**DOCUMENT 00 90 00**  
**ADDENDUM**

**ADDENDUM No.:** 2

**DATE:** April 1, 2025

**RE:** WESTERN TECHNICAL COLLEGE  
STUDENT SUCCESS CENTER RENOVATION  
400 N. 7TH STREET  
LA CROSSE, WISCONSIN 54601

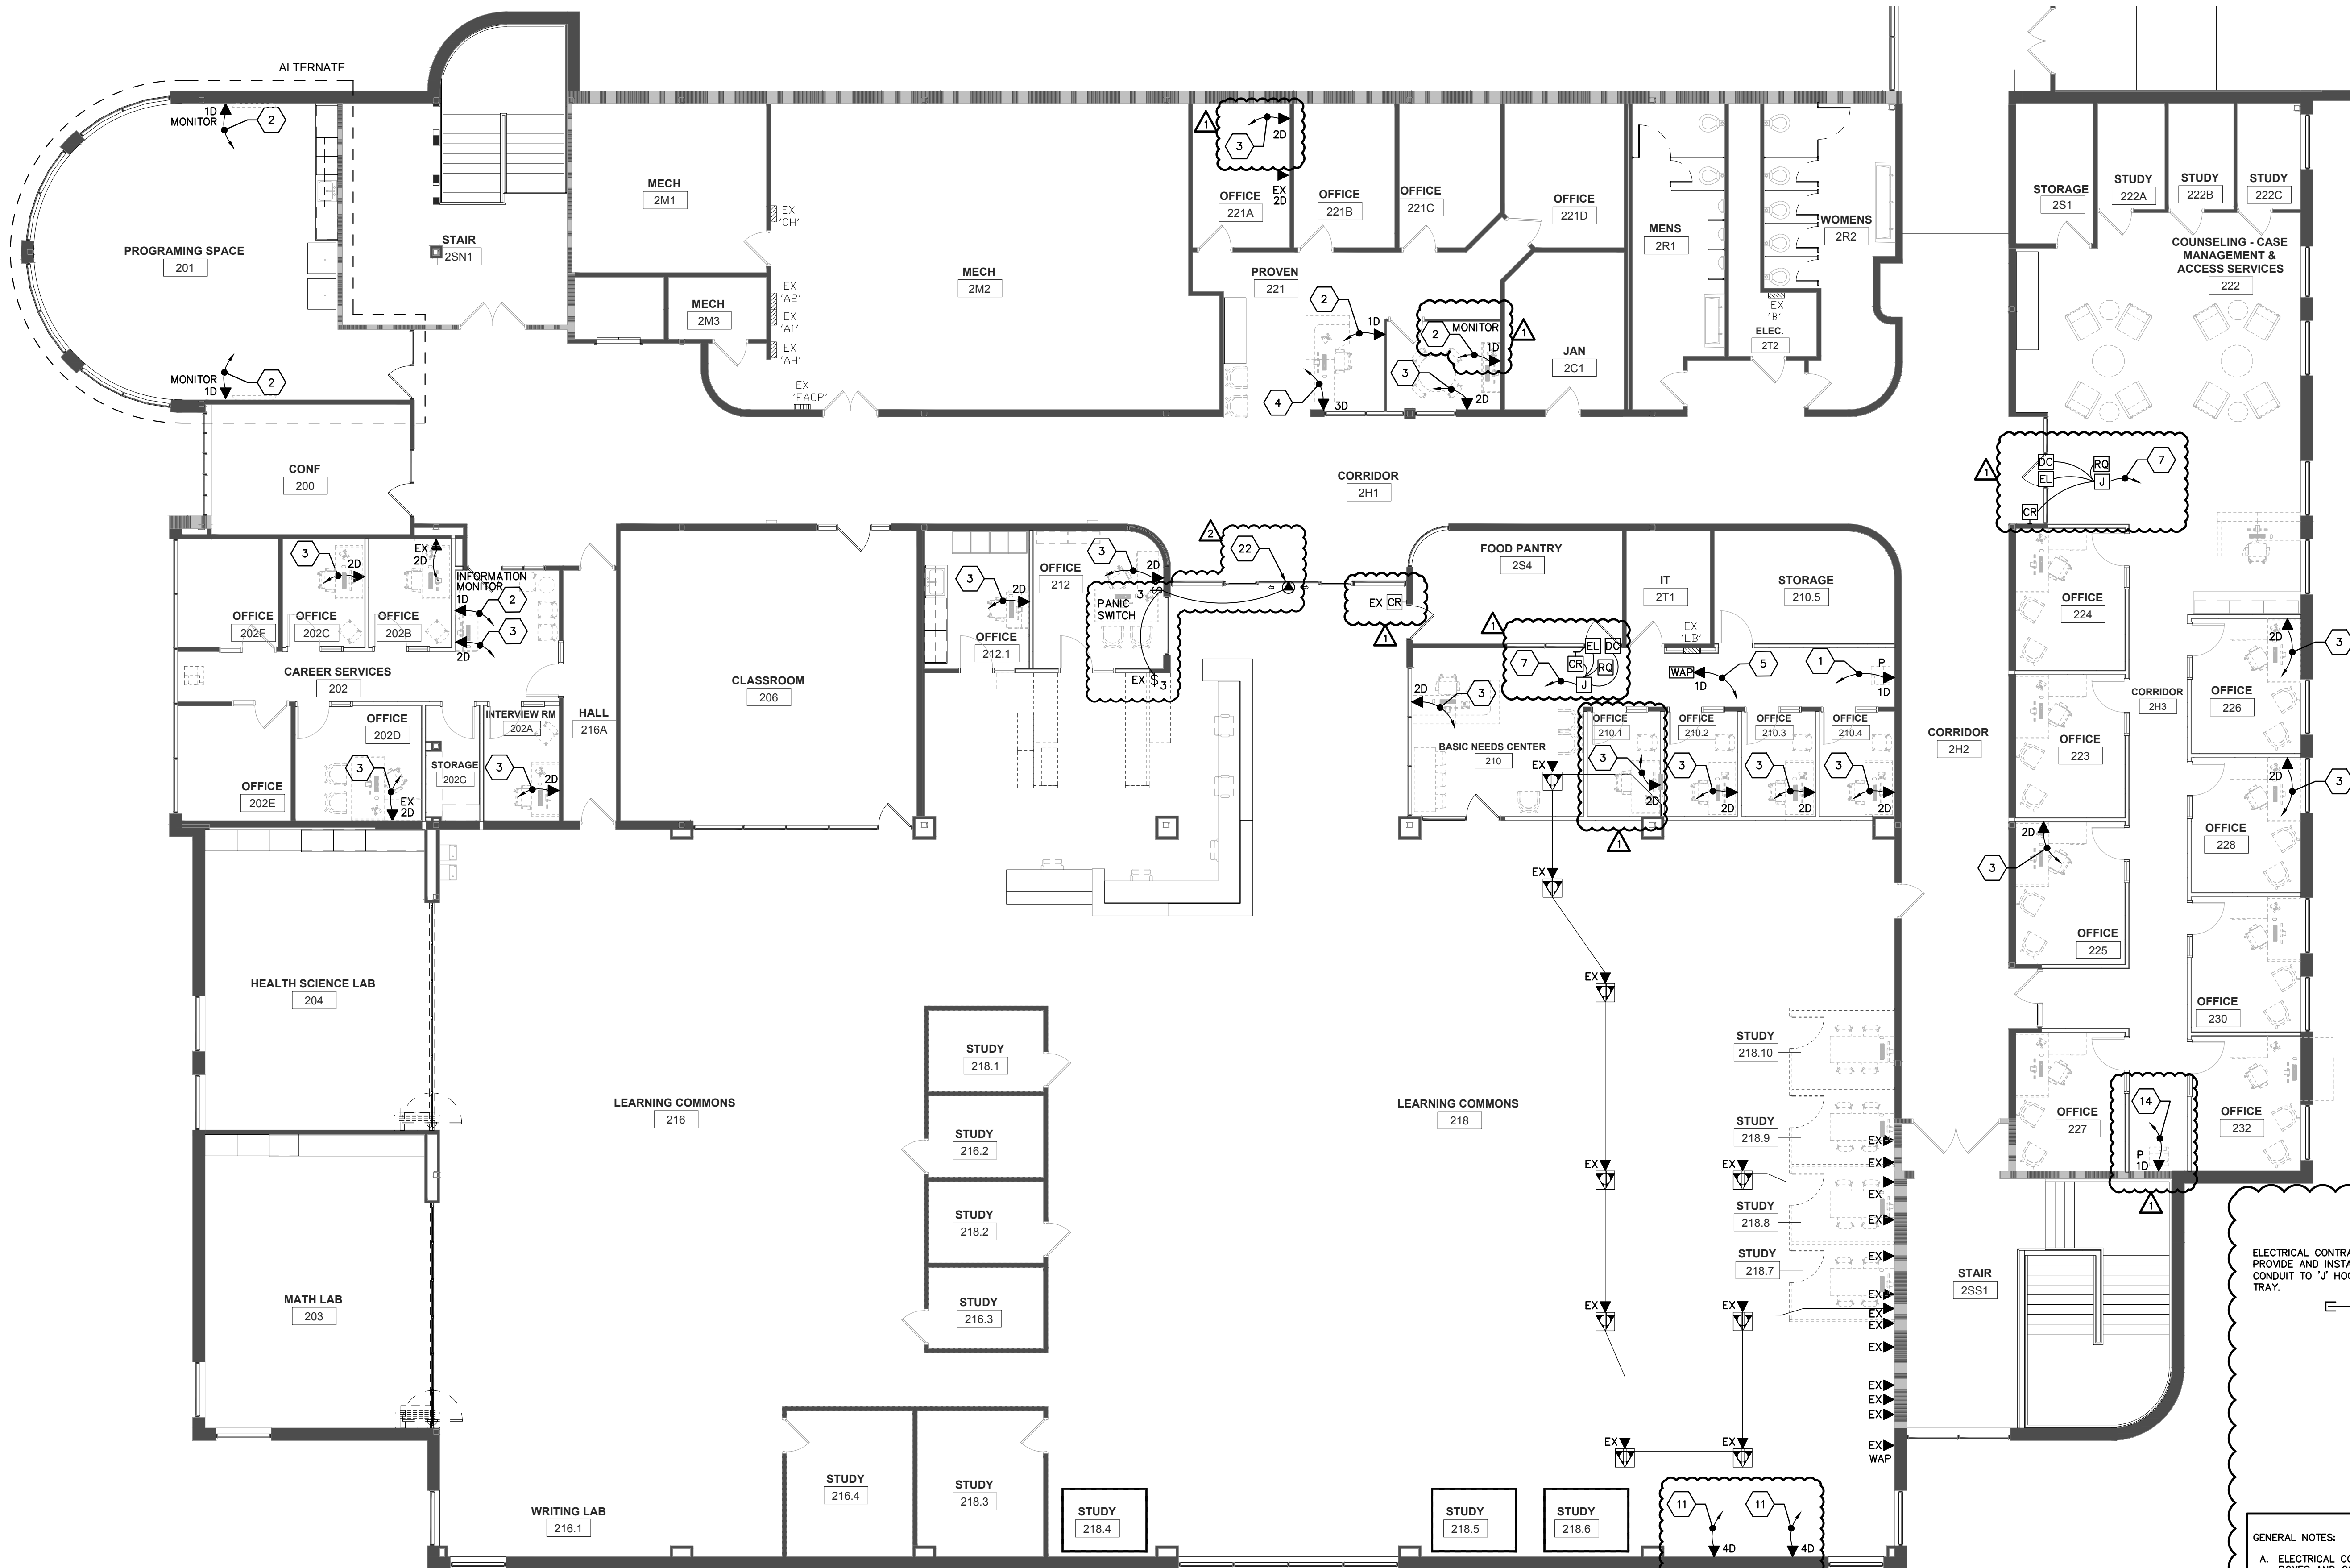
19. Sheet E302 SECOND FLOOR LOW VOLTAGE PLAN 30"x42"
  - a. See the revised sheet included in this addendum. Disregard the previous version.
  - b. Refer to Office #212;

- i. Provide Two (2) 3-way switches for electric lock control to main door. Refer to clouded change labeled addendum 2.
